**SP50-03**

# S E R V I C E N O T E

## Agilent SP50 Optical Board Test System

### **Cable Stress On Rear Hood Hinge**

**Figure 1**

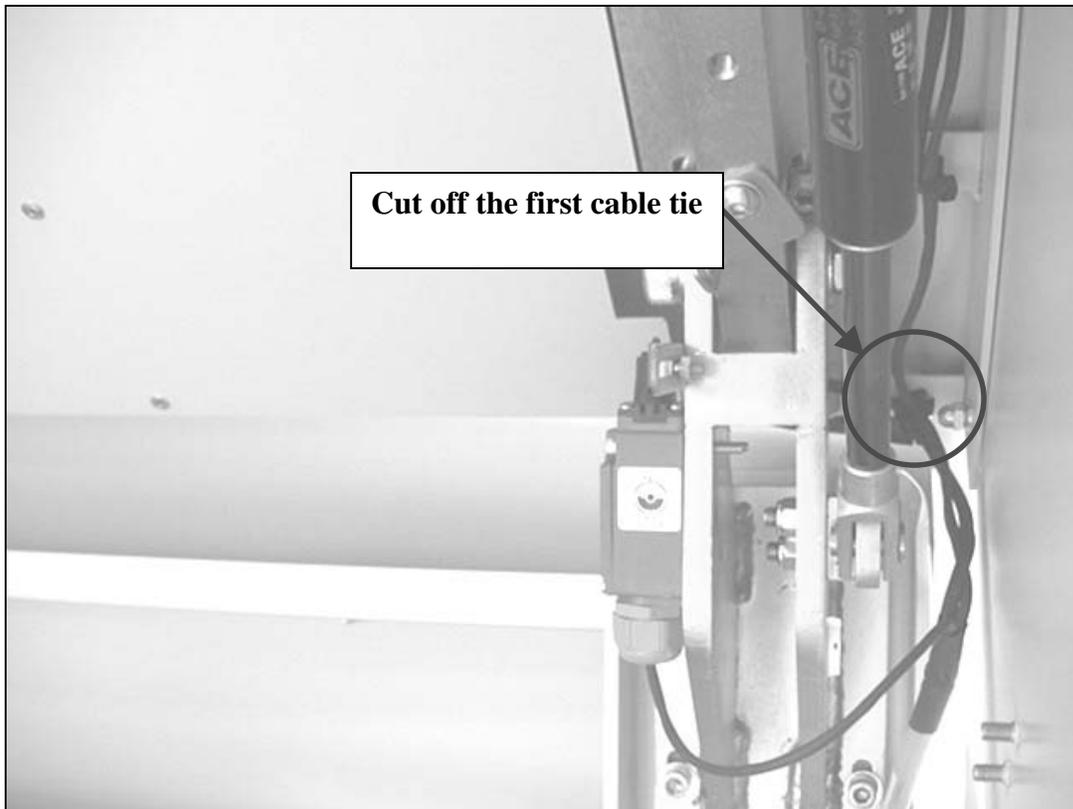
A cable on the SP50 System is being overly stressed when the Hood Assembly is opened and closed.

1. Cut off the cable tie on the first cable tie cleat.  
The position is shown in **Figure 1**.
